WATTS BAR NUCLEAR PLANT (WBN) UNITS 1 AND 2 - REQUEST FOR ADDITIONAL
INFORMATION ON FSAR CHAPTER 3 AS REVISED BY AMENDMENT 79 (TAC NOS. M88488
AND M88489)

This letter provides TVA's response to the NRC's request for additional
information (RAI) dated October 11, 1994, concerning the subject FSAR
chapter for WBN.

WATTS BAR NUCLEAR PLANT UNITS 1 AND 2 FINAL SAFETY ANALYSIS REPORT (FSAR), CHAPTER 3 REQUEST FOR ADDITIONAL INFORMATION (RAI) RESPONSE

Figure 5.5 11. Crossover Leg Vertical Run Restraint.

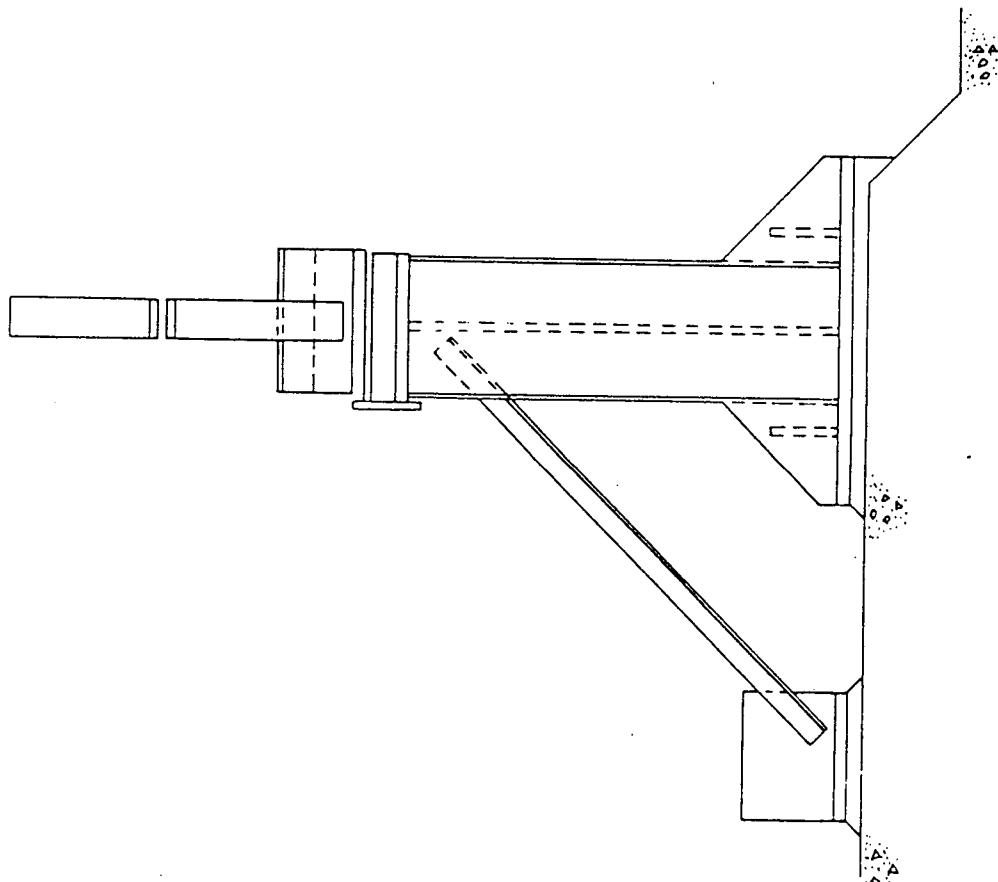
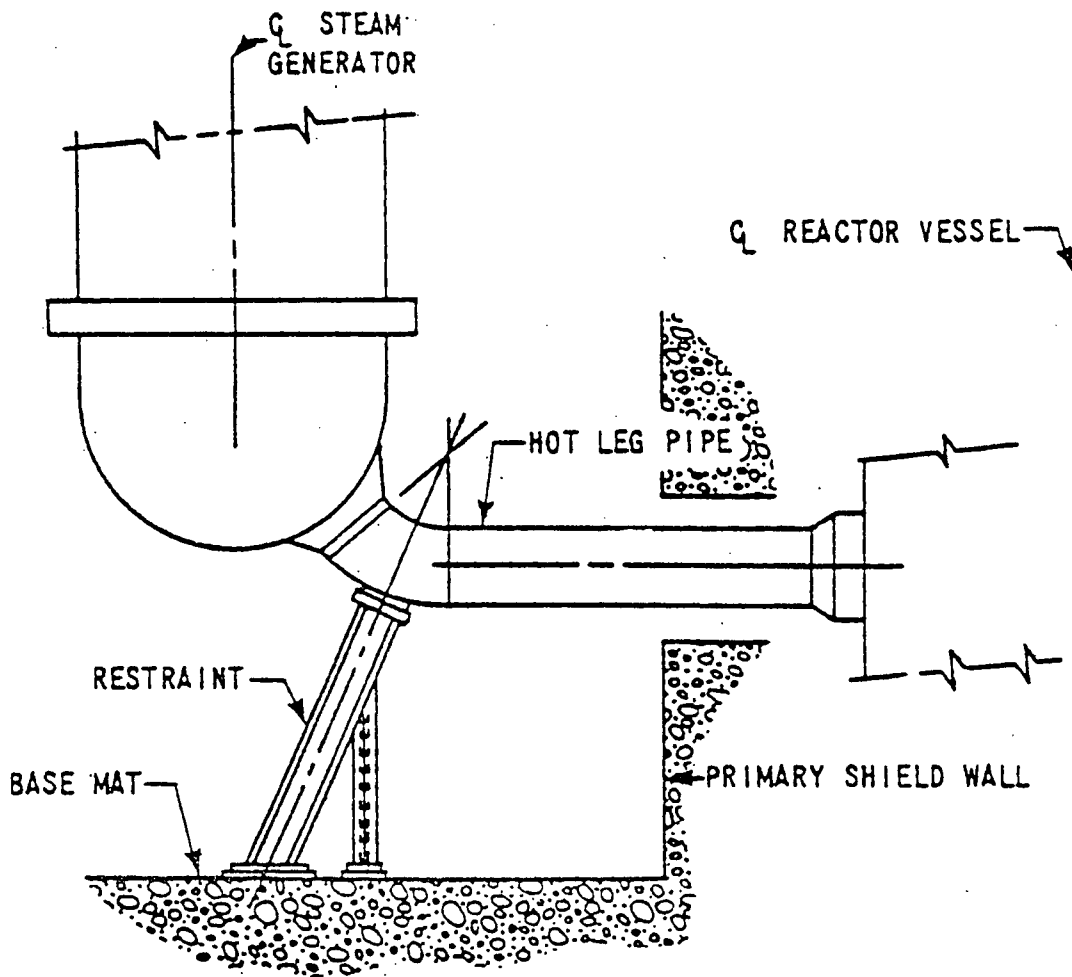
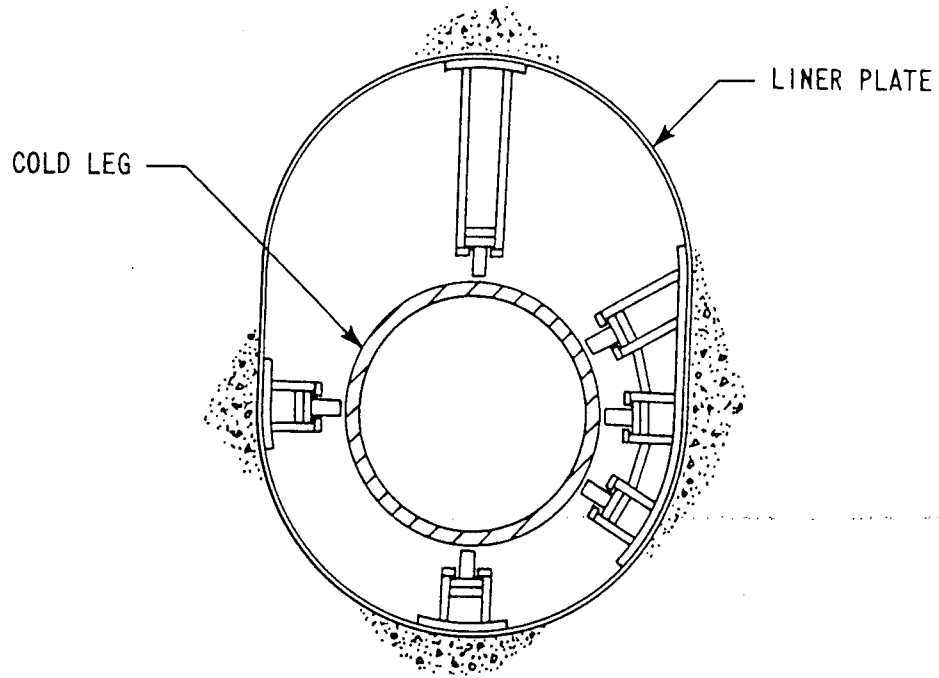
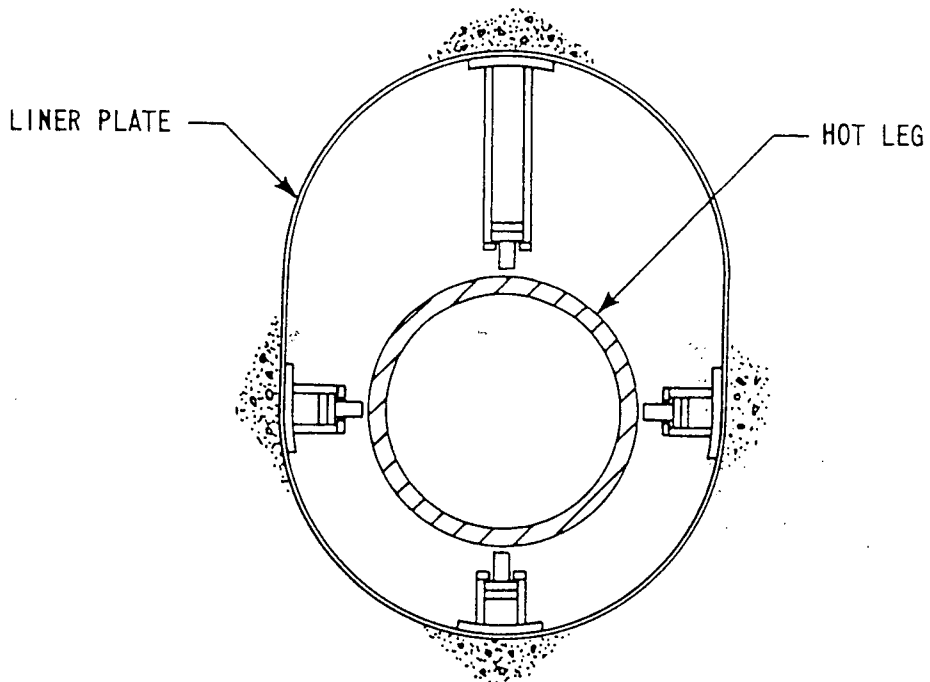
1. Geometry and sketches of the model,
2. Engineering data, such as, mass, spring, damping, size and location of the gaps, location of one-way hangers,
3. Description of modelling of gap and one-way hanger and validation of such model,
4. Detailed description of four linearized NSSS support stiffness and a discussion of how such supports adequately represent the nonlinear system being evaluated,
5. Discussion of governing equation of motion and the validation of numerical integration algorithm including stability and error estimate as discussed in "Analysis of Numerical Methods," E. Isaacson and H. B. Keller, 1966 .
6. Validation of overall model and
7. Summary of the calculated stresses of the critical members both in concrete structure and piping and supports, corresponding allowable stresses and references from which the allowable stresses are quoted."

Gaps are provided in NSSS component support arrangements to enable the virtually unrestrained thermal movement of the loops and the components during plant operation. However, the support structures are of welded steel construction and fabricated in such a way that while the supports permit unrestrained thermal growth of the supported systems, the supports would provide restraints to the vertical, lateral and rotational movement resulting from seismic and/or accident conditions. This is accomplished by using (1) pin ended columns for vertical support and (2) girders, bumper pedestals, hydraulic snubbers, and tie rods for lateral support. The detailed description for the NSSS component supports is provided in FSAR Figures 5.5-6 through 5.5-13 (See Attachment 1).
